DETERMINATION
PLAN

PROJECT:
Pennygate
Spalding
Lincolnshire

TITLE:
Tie In Details - Tarmac to Block Paving and Existing Road to Road 1 Tarmac Construction

DRAWING No:
05-17-17-A

ROUNDABOUT TO ROAD 4 TIE IN DETAIL 1:10

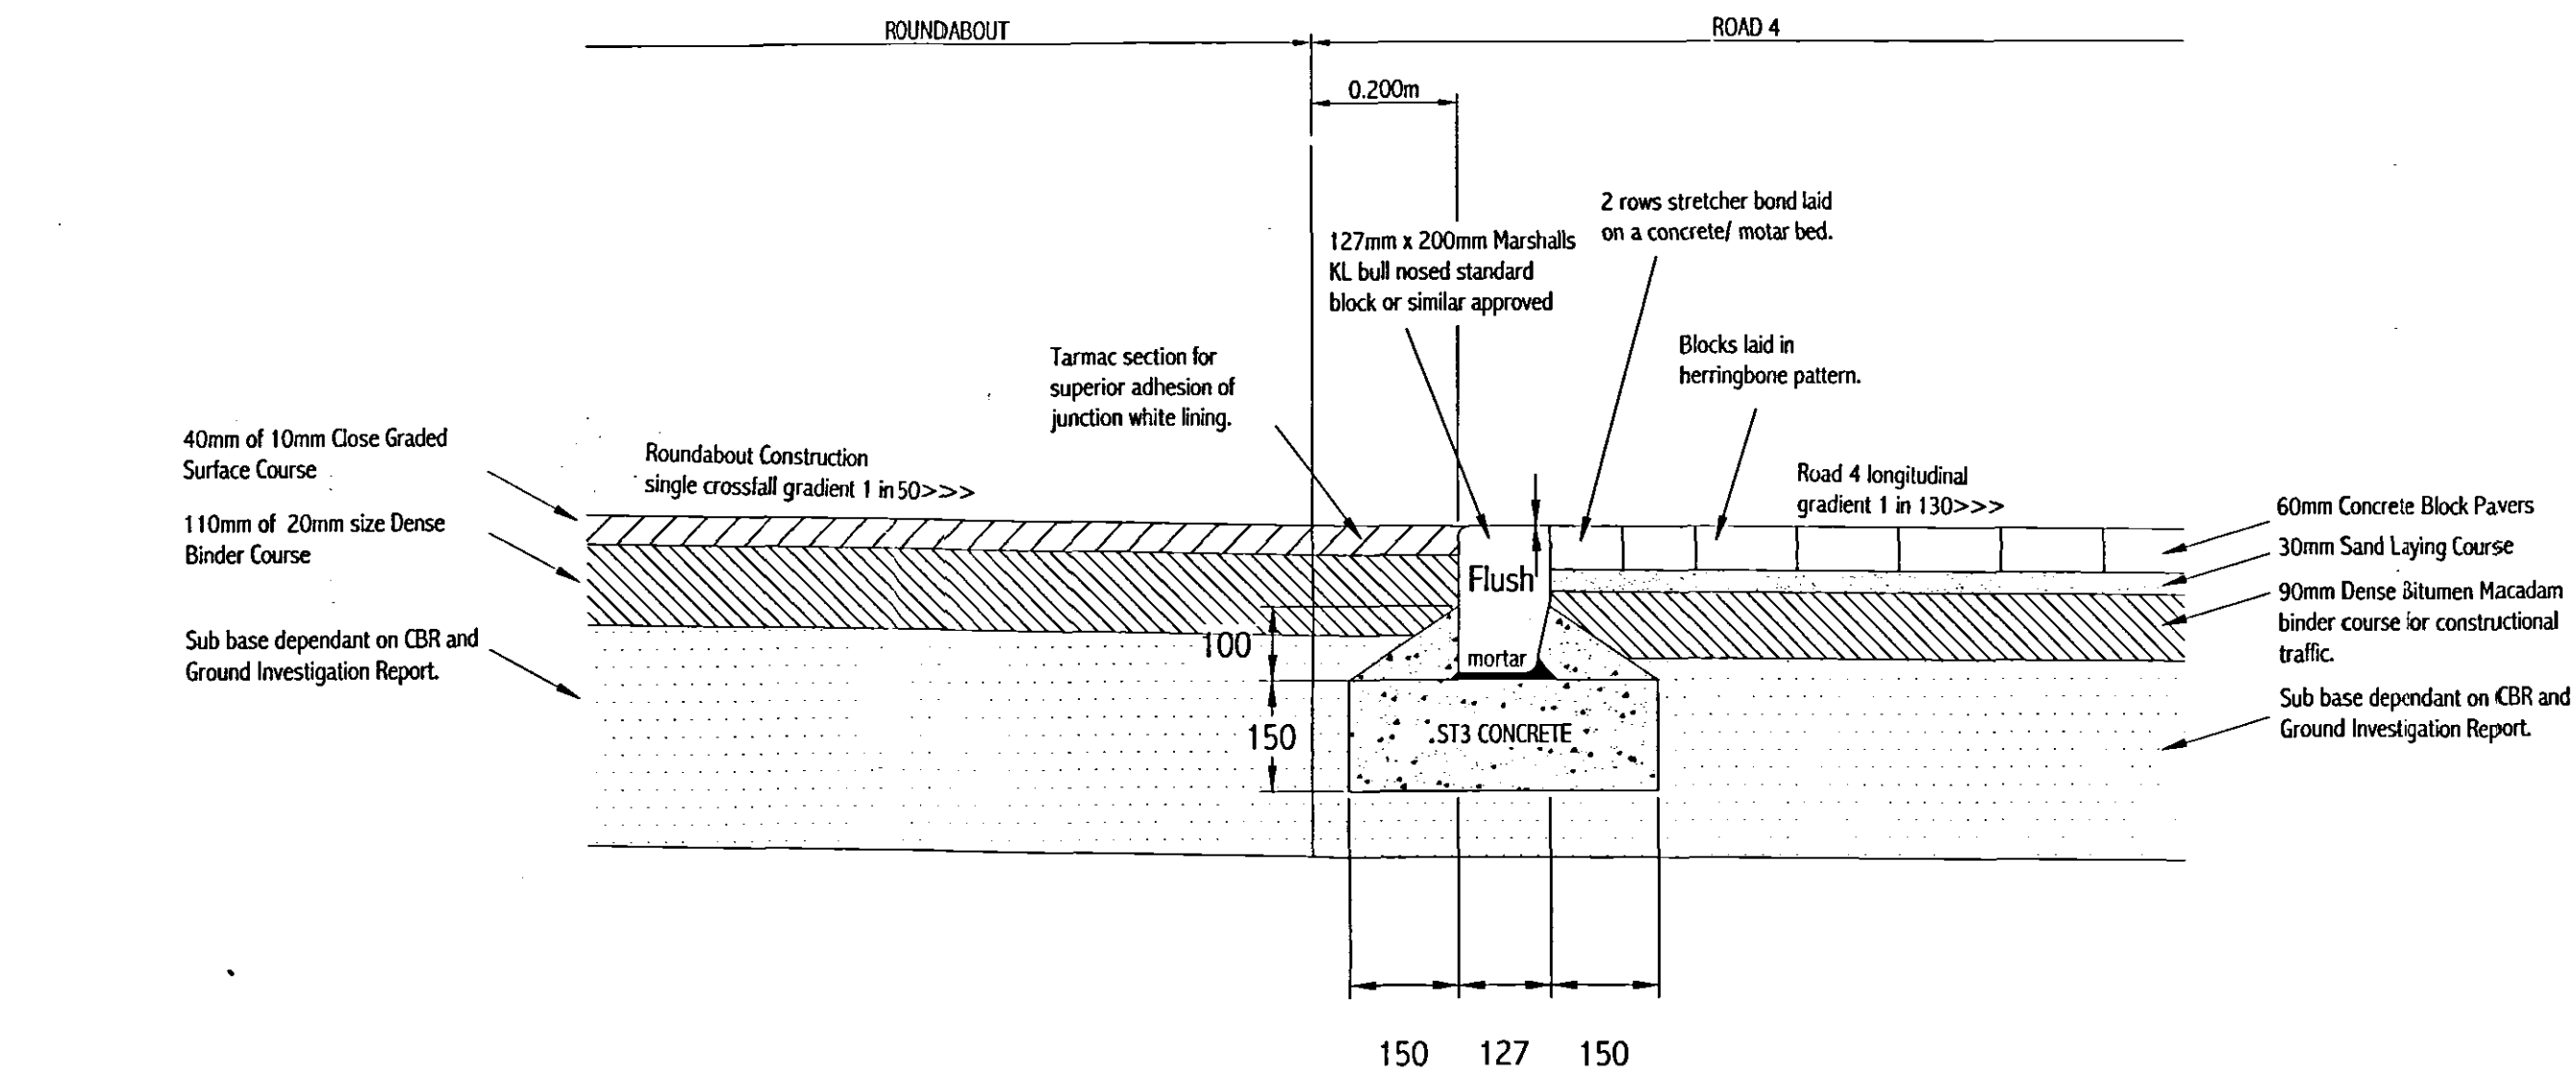
REF.	DESCRIPTION	DATE	BY
A	Crossing point on roundabout details removed, PCC DW kerb on roundabout to road 4 details replaced as per LCC comments.	29.07.05	GW

PCC KERB UNITS ARE NOT TO BE USED. MARSHALLS KEYKRB (KL) BULLNOSED STANDARD BLOCK SHOULD BE USED INSTEAD TO ACT AS AN EDGE RESTRAINT AS INSTRUCTED AND AGREED BY DEAN WHITEHEAD OF LINCOLNSHIRE COUNTY COUNCIL 29.07.05
